REF. & REV. MARCH 2005 CITY OF MADERA

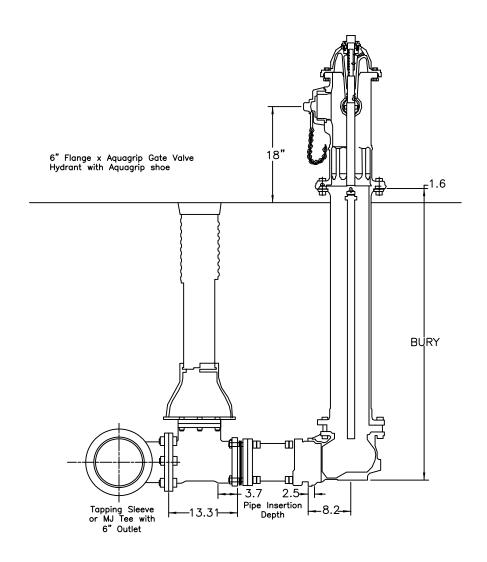
IN LIEU OF POURING A THRUST BLOCK ON A FIRE HYDRANT RUN, THE CONTRACTOR SHALL HAVE THE OPTION TO INSTALL A MUELLER A423 FIRE HYDRANT WITH AN AQUQGRIP SHOE AND A MUELLER GATE VALVE WITH AN AQUQGRIP X FLANGE END CONNECTION, (A2361-76) AS DETAILED IN THE ATTACHED DRAWING. IF THE HYDRANT RUN IS SUCH THAT IT REQUIRES A PIPE JOINT THEN AN AQUQGRIP RESTRAINED COUPLING SHALL ALSO BE USED (6"=MODEL#AGC0690).
